BAW-2119
October 1990

RELOAD REPORT
Catawba Unit 1, Cycle 6

B&W Fuel Company
P. O. Box 10035
Lynchburg, Virginia 24506-0935

8. PROPOSED MODIFICATIONS TO TECHNICAL SPECIFICATIONS AND COLR

Figure 2.1-1 Reactor Core Safety Limits - Four Loops in Operation

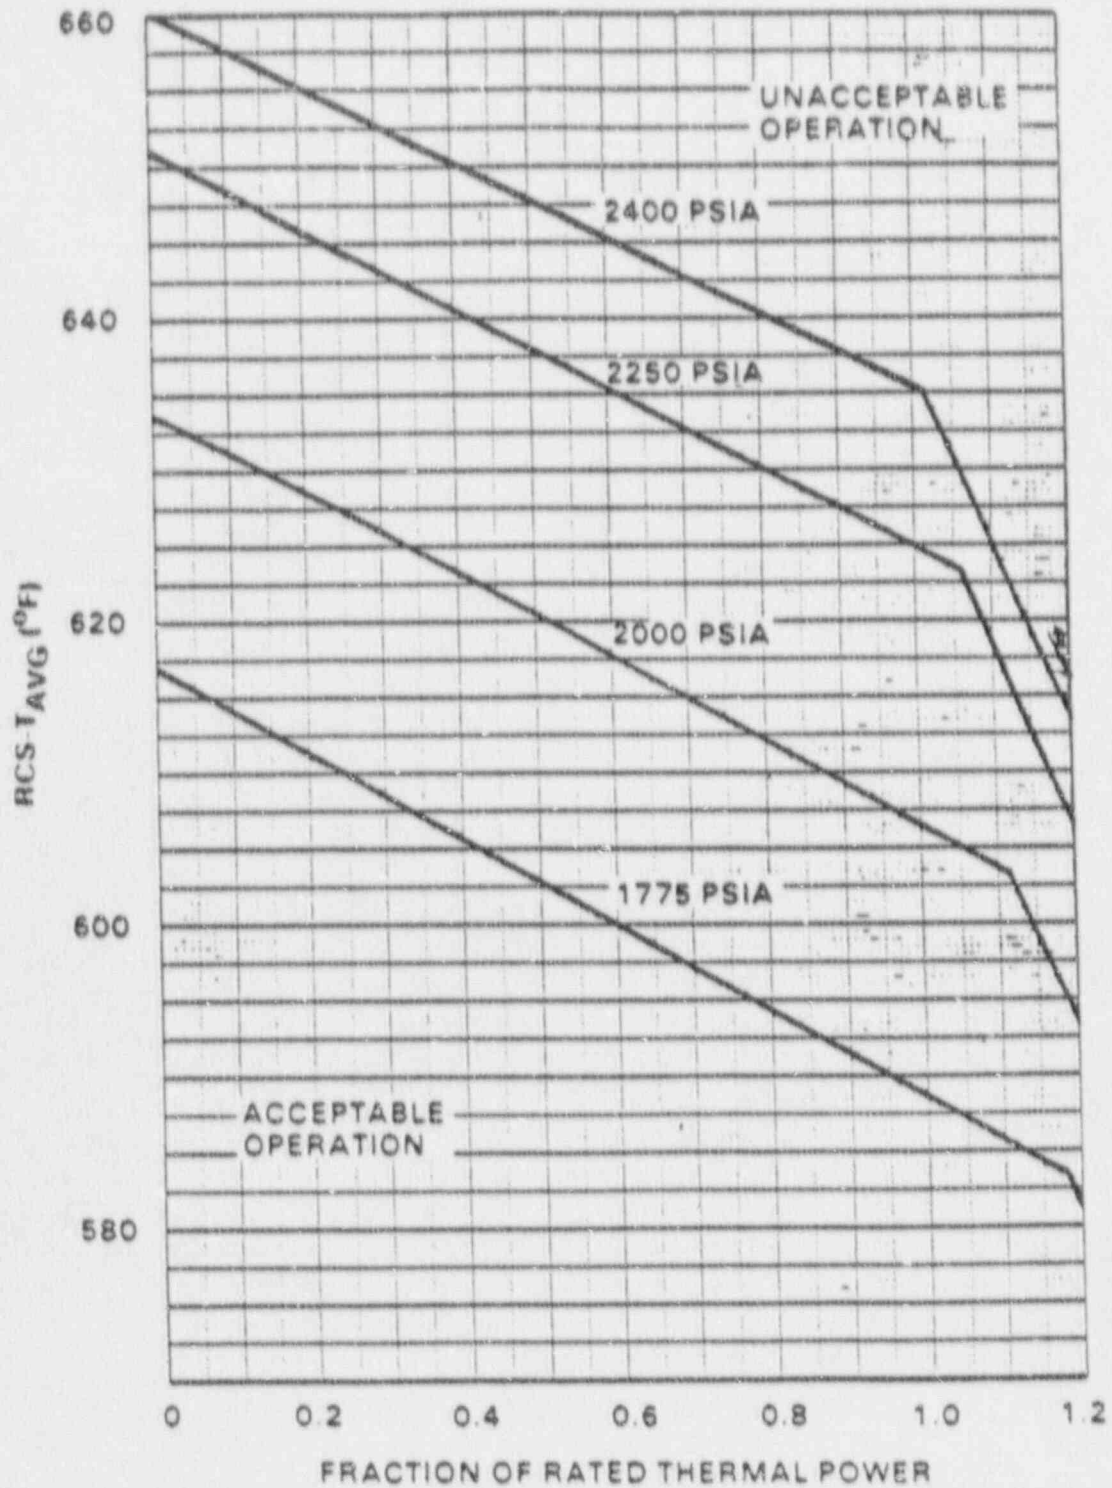
Applicable Tech. Spec. No.	Reason for Change
2.1.1.1	changed C:F correlation increased F_{DP} for Mark-BW fuel reduced minimum measured RCS flow
2.2.1	completed RID bypass removal reduced minimum measured RCS flow increased error allowances on certain reactor trip instrumentation
3/4.2.1	deleted baseload operation
3/4.2.2	changed F_0 methodology
3/4.2.3	changed $F_{\Delta H}$ methodology separated RCS flow and $F_{\Delta H}$ relationship
3/4.2.4	increased the tilt ratio at which a power reduction is required rewrote LCD to be consistent with Westinghouse SIS
3/4.2.5	incorporated RCS flow as a DNB parameter removed power/flow tradeoff dependence on R reduced minimum measured RCS flow
4.5.2	changed flow and developed pressure requirements to be consistent with revised accident analysis flow assumptions
6.9.1.9	reflected the change to BWFC operating limit methodology

Figure 3.2-1. Reactor Coolant System Total Flow Rate Versus Ratio Thermal Power - Four Loops in Operation

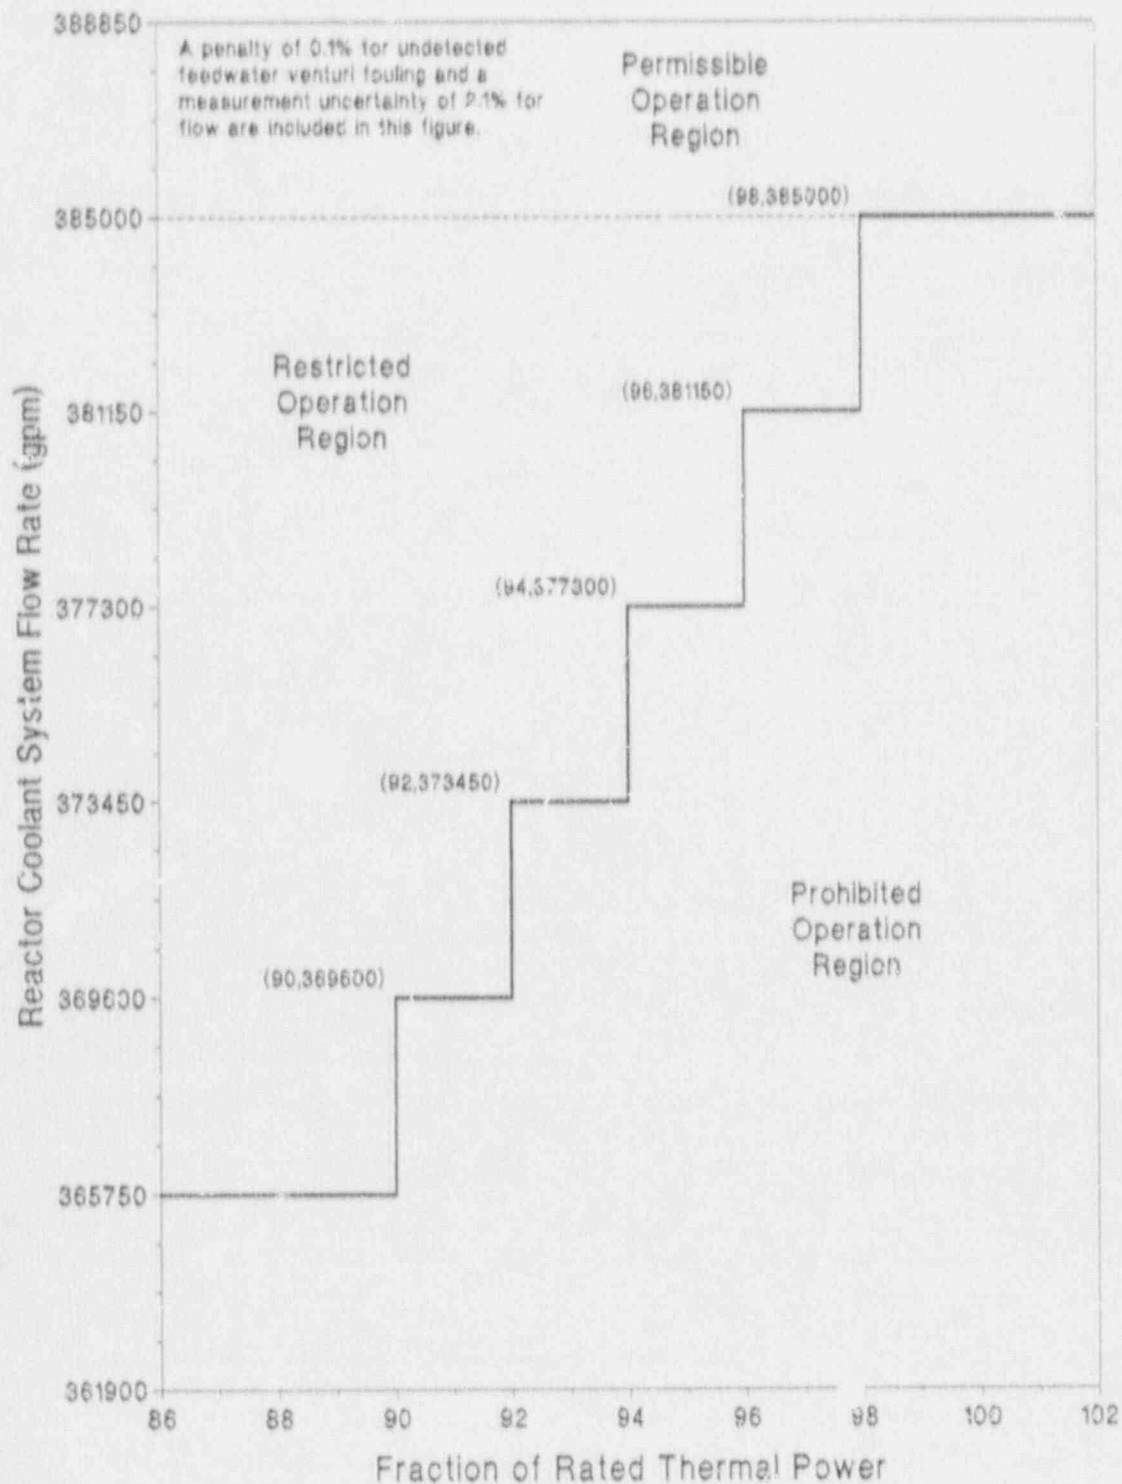
specified on Figure 3.2-1,

on Figure 3.2-1,

When Reactor Coolant System flow rate and $\frac{N}{\Delta H}$ are measured, no additional allowances are necessary prior to comparison with the limits of ~~the figure~~ ^{Figure 3.2-1 since a} specified in the COLR. Measurement errors of 2.1% for Reactor Coolant System total flow rate and 4% for $\frac{N}{\Delta H}$ have been allowed for in determination of the design DNBR value.
